UNITED STATES  
NUCLEAR REGULATORY COMMISSION  
WASHINGTON, D. C. 20555

AMENDMENT TO FACILITY OPERATING LICENSE

SAFETY EVALUATION BY THE OFFICE OF NUCLEAR REACTOR REGULATION

OCONEE NUCLEAR STATION, UNITS 1, 2, AND 3

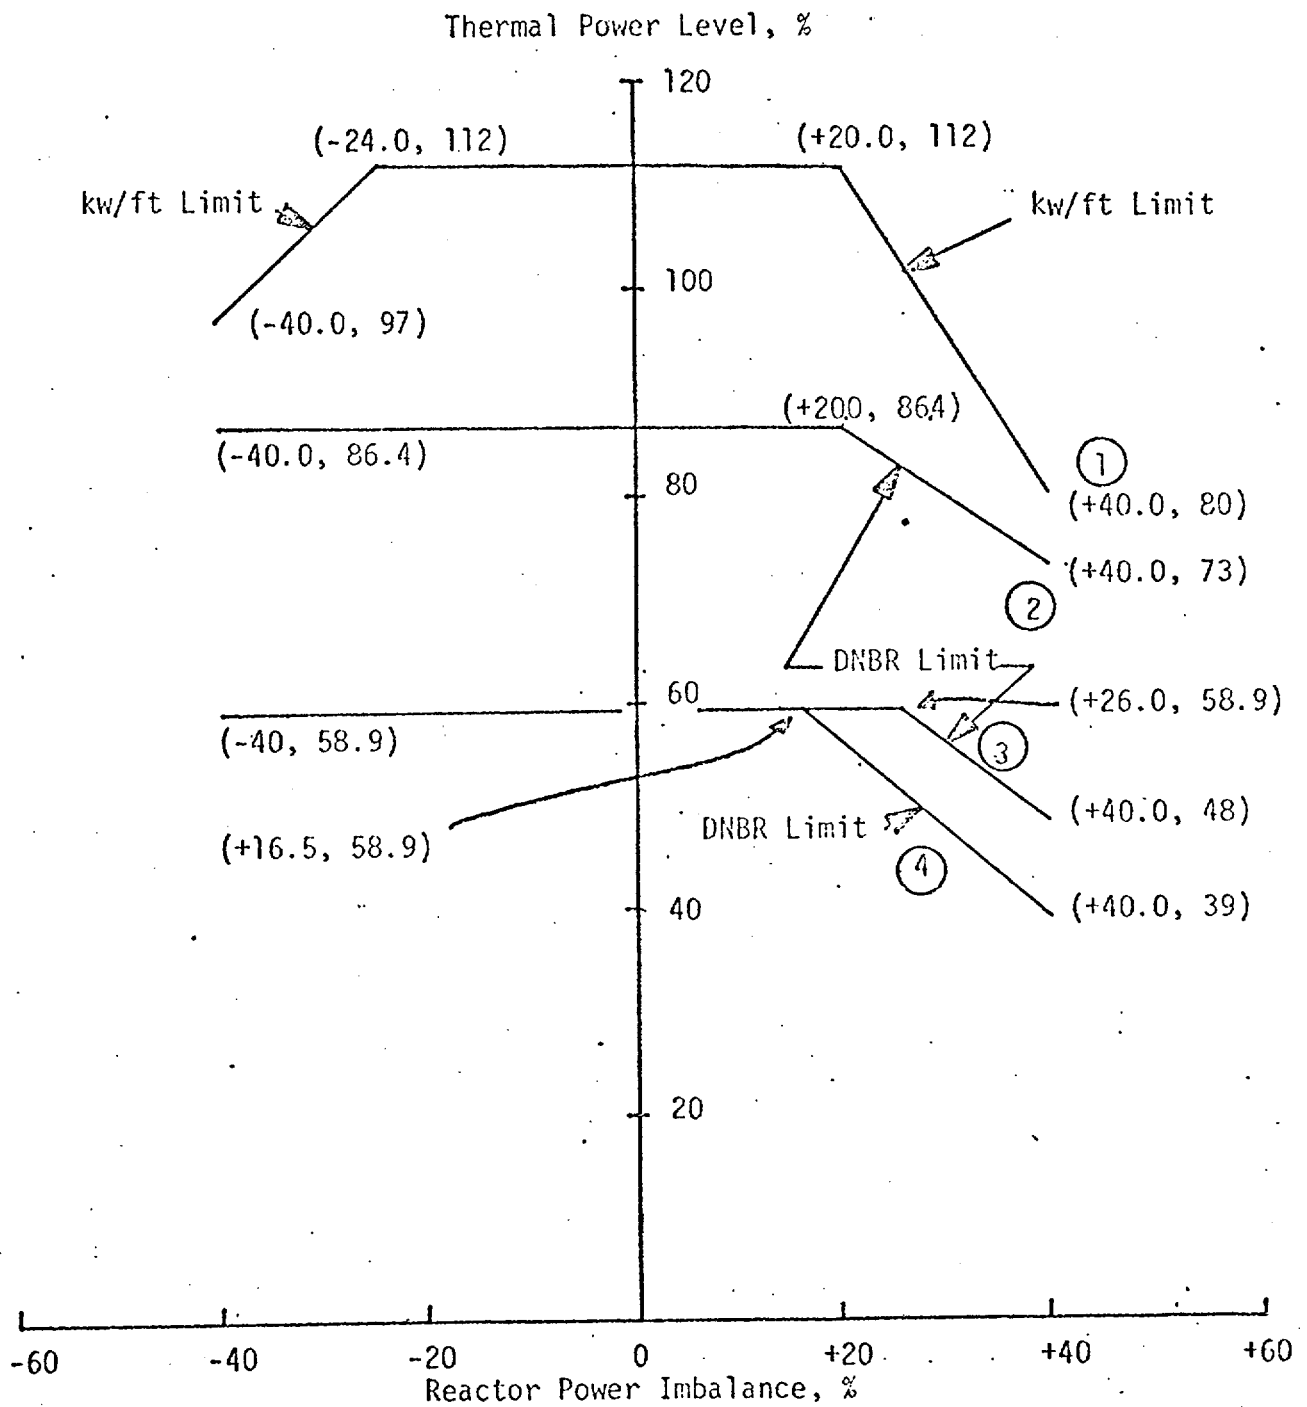
The maximum thermal power for three pump operation is 86.4% - Unit 2  
86.4% - Unit 3  
due to a power level trip produced by the flux-flow ratio  $75\% \text{ flow} \times 1.07 = 80\%$   
 $1.07 = 80\%$   
power

plus the maximum calibration and instrument error. The maximum thermal power for other coolant pump conditions are produced in a similar manner. A flux-flow ratio of 0.961 is used for single loop conditions.

For each curve of Figure 2.1-3B, a pressure-temperature point above and to the left of the curve would result in a DNBR greater than 1.3 or a local quality at the point of minimum DNBR less than 15 percent for that particular reactor coolant pump situation. The 1.3 DNBR curve for four-pump operation is more restrictive than any other reactor coolant pump situation because any pressure/temperature point above and to the left of the four-pump curve will be above and to the left of the other curves.

Figure 2.1-2B

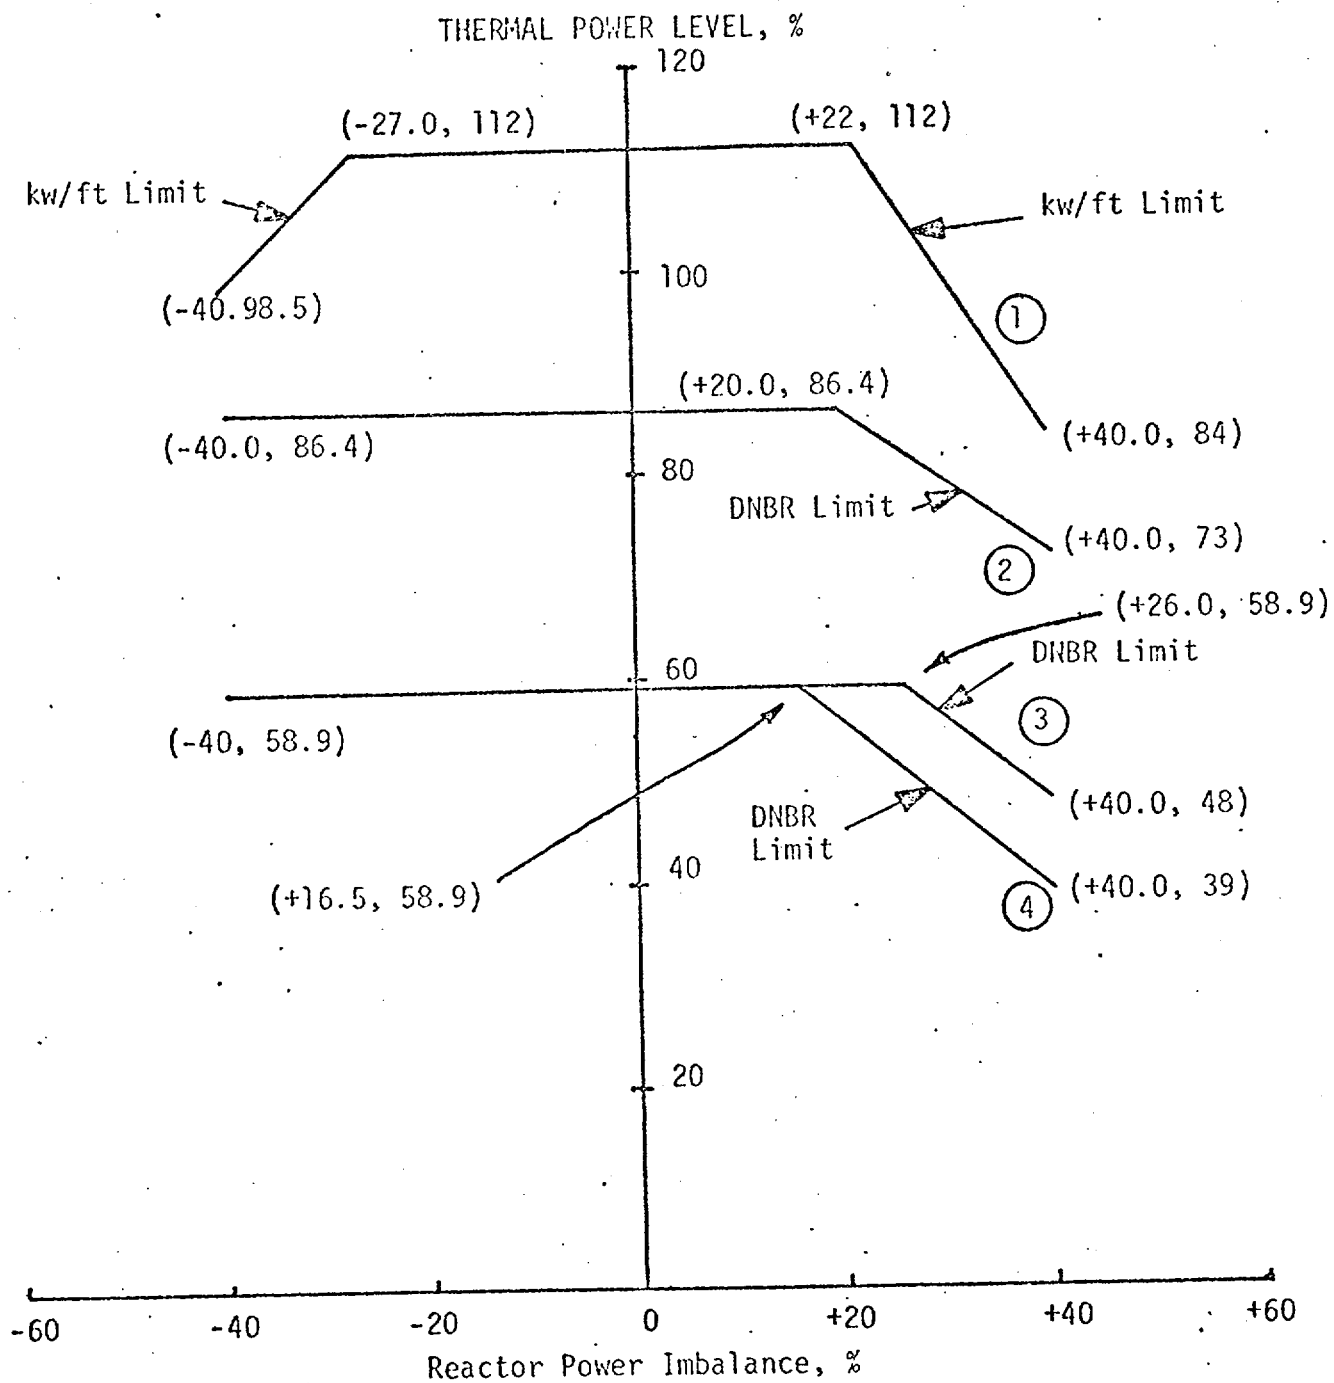
These amendments (1) modify the axial power imbalance limits for the Core Protection Safety Limits and the Reactor Protection System Maximum Allowable Setpoints, (2) reduce the flux/flow ratio from 1.07 to 0.961 for single-loop operation, and (3) change the maximum thermal power for three-pump operation from 86.0% to 86.4%.

CORE PROTECTION SAFETY LIMITS  
UNIT 2

The licensee's proposed amendments which would relax the axial power imbalance setpoints for the Core Protection Safety Limit and the RPS setpoints is based on the fact that after about 100 EFPD of operation, the power peaking factor which exists near BOL becomes an overly restrictive criterion for establishing the axial power imbalance limitations. We agree in that with the fuel depletion experienced through the initial 100 EFPD of operation a corresponding decrease in the maximum linear heat generation rate would be realized. This decrease in the heat generation rate would result in an increase in the core safety margin over the value existing at BOL. By relaxing axial power imbalance limitations, as is proposed, an increase in peaking factor would result with a consequent increase in linear heat generation rate. It has been determined, however, that the reduction in peaking factor realized after about 100 EFPD of operation more than compensates for the increase in peaking factor which would result from the proposed revised power imbalance limits. The original safety margins are therefore maintained. At the present time, Oconee Units 2 and 3 have operated through approximately 300 and 230 EFPD, respectively. We, therefore, find the proposed changes to the axial power imbalance limits to be acceptable.

Figure 2.3-2B

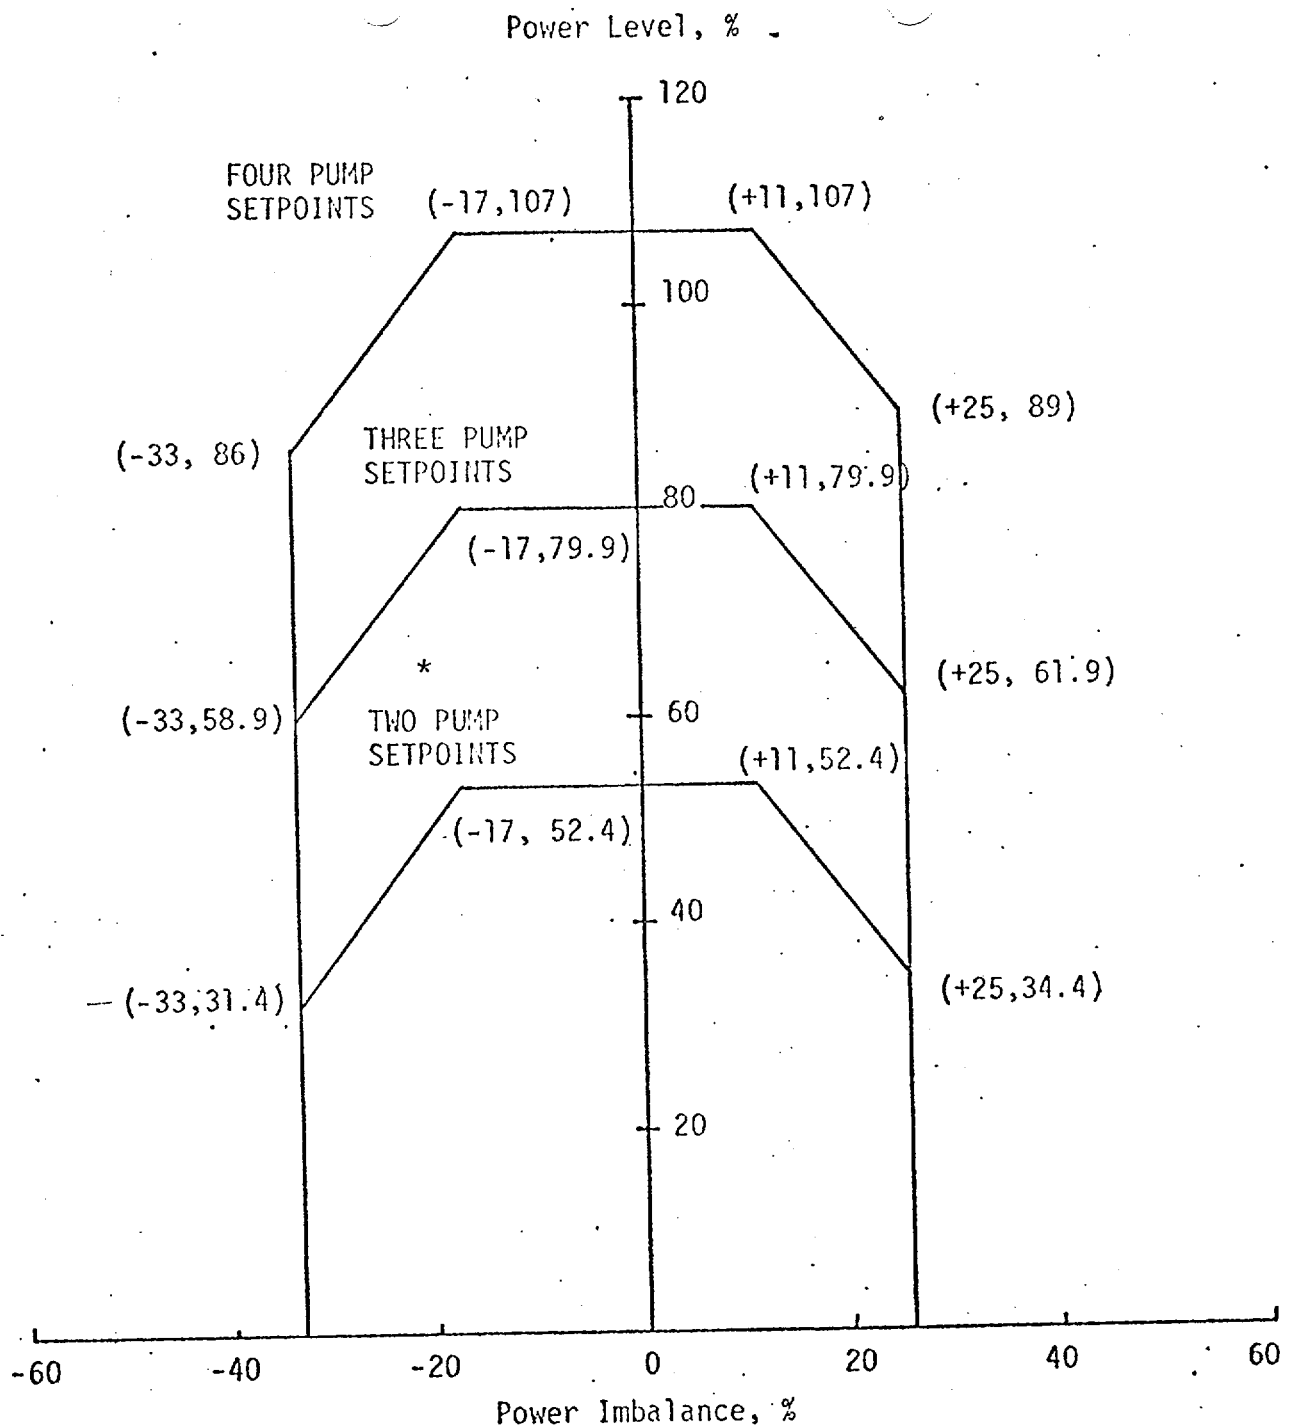
\*For two pumps in one loop, the flux-flow setpoint must be 0.961.

PROTECTIVE SYSTEM MAXIMUM ALLOWABLE SETPOINTS

UNIT 2

The licensee is also proposing a reduction in the flux/flow ratio for single-loop operation in order to provide adequate margin from the revised imbalance safety limits discussed above. The flux/flow ratio determines the RPS trip setpoint limits and is derived from a combination of reactor coolant system flow in percent and the existing axial power imbalance. The proposed reduction from 1.07 to 0.961 would result in a more restrictive trip setpoint for the single-loop mode of operation and has been determined to adequately compensate for the revised power imbalance limitations discussed above.
